RE: Construction Services for Idle Hour Park Improvements
LFUCG Bid No. 103-2015

Below is our pricing to perform the undercut of unsuitable material for the roadway and retaining wall as detailed in the CSI reports dated May 24th and May 25th, 2016. I have adjusted the quantities based on CSI recommendation to undercut five (5) feet outside the edge of the roadway and include undercut under the retaining wall.

PROJECT:	Idle Hour Park	JOB NUMBER:	LX160075
CLIENT:	Bluegrass Contracting	WEATHER:	Clear, Low 80's
CSI PROFESSIONAL:	Shawn Ferrell - NICET II, SI	DATE:	Tuesday, May 24, 2016

PROJECT:	Idle Hour Park	JOB NUMBER:	LX160075
CLIENT:	Bluegrass Contracting	WEATHER:	Clear, Low 80's
CSI PROFESSIONAL:	Shawn Ferrell - NICET II, SI	DATE:	Wednesday, May 25, 2016

Figure 1: Approximate Area of Observations

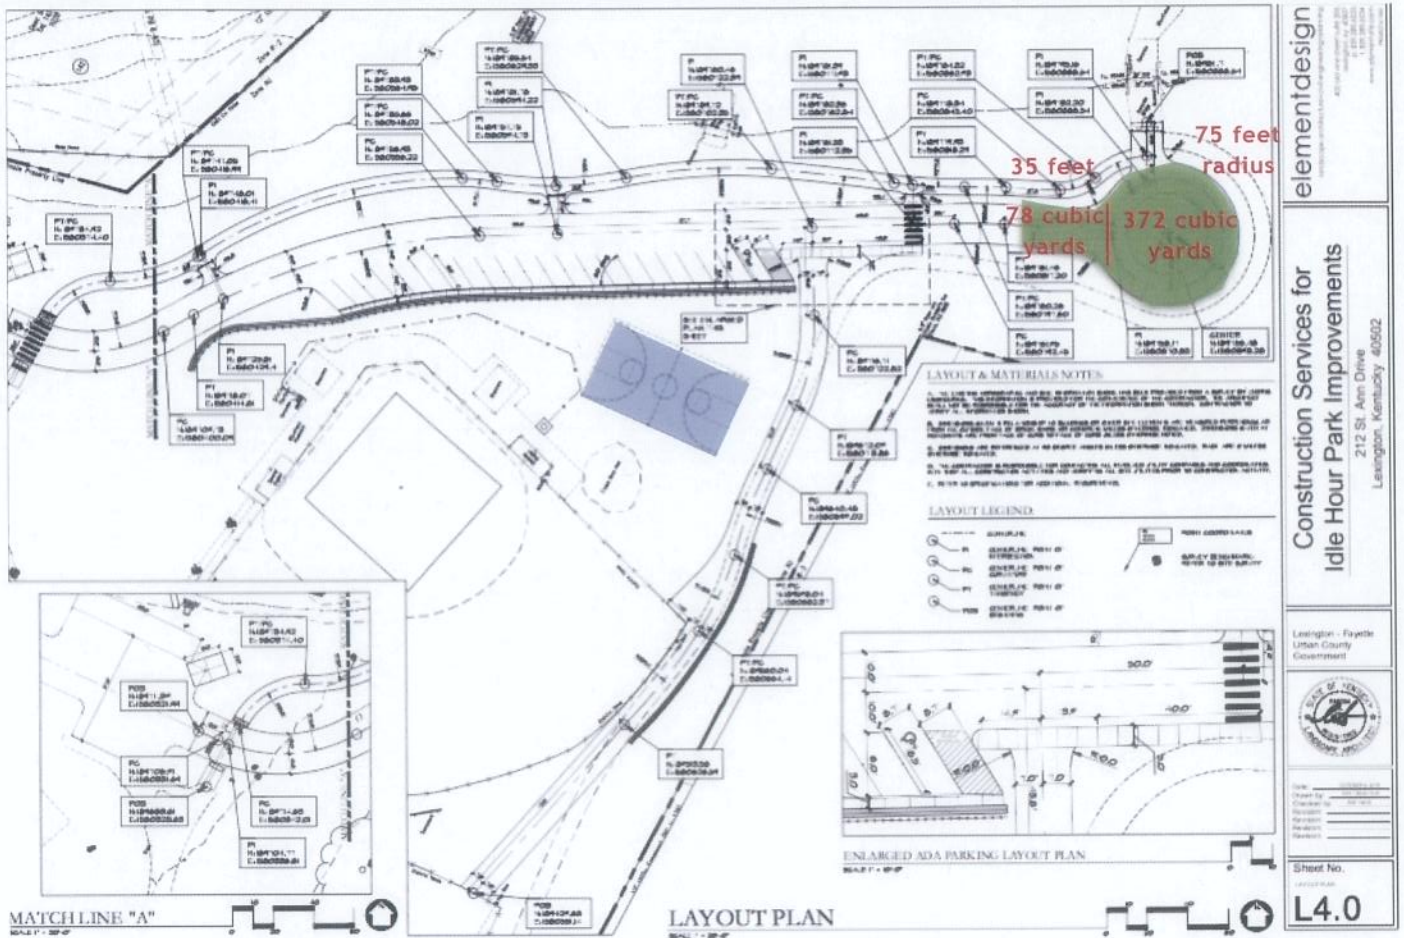
CSI observed a proof roll conducted by the contractor for the soil sub-grade approximately 35 feet of the roadway and the cul-de-sac utilizing a loaded tri-axle dump truck. The proof-roll consisted of the loaded truck routing over the sub-grade in a forward and backward motion, then moving laterally one tire width and repeating the motion until the exposed sub-grade had been rolled. The proof roll revealed soft pumping material throughout the roadway and the cul-de-sac. The pumping was evident throughout the full width of the proposed roadway. The soft pumping area measured to be 35 feet by 20 feet for the roadway and 75 feet radius of the cul-de-sac. We would recommend to extend the roadway undercut 5 feet beyond the roadway to maintain stability for a total of 450 cubic yards measured to be undercut and replaced.

Based on our reconnaissance of the site and our understanding of the project we believe the soft soils encountered will not support the proposed construction and will need to be stabilized to facilitate the construction above the subgrade. Such stabilization can be achieved by undercutting the soft materials down two feet, lining the soft area with a reinforced geotextile fabric and backfilling with a #2 stone like aggregate back up to the designed subgrade elevation. Once the stabilization has occurred the area should be evaluated by proof rolling to verify stability prior to placement of the pavement section.

813 CY Unsuitable Soil Removal @ \$26 CY = \$21,138.00
1,057 TN #2 Stone @ \$28/TN = \$29,596.00
1,220 SY BX1200 @ \$3/SY = \$3,660.00
